Development Facilitation Team (DFT) – Review Comments

Project No: PR-2022-007299 Date: 6/26/2024 Agenda Item: #1 Zone Atlas Page: K-10

Application For: SD-2024-00113 – PRELIMINARY/FINAL PLAT

Project Name: 7226 Central Ave SW

FIGURE 7.2.41 Street Element Dimensions Along Major Roads

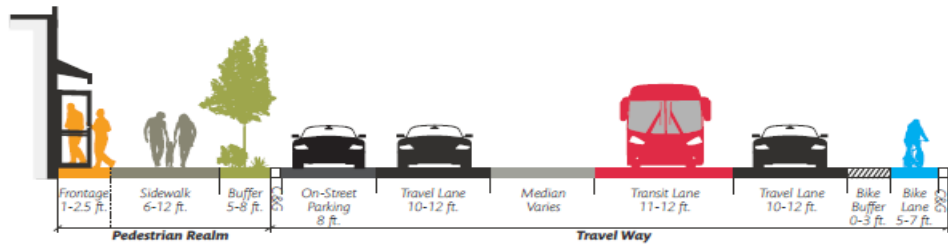
Confirm if the sidewalk and landscape buffer zone requirements are being met per the DPM requirements shown below (Central is a Principal Arterial within a center and requires A 10-foot-wide sidewalk with a 6 – 8-foot landscape buffer. Amanda St. is a local road and requires a 5-foot-wide sidewalk and a 4-6-foot-wide landscape buffer. All sidewalks must have a 4-foot ADA pathway around all obstructions within right-of-way).
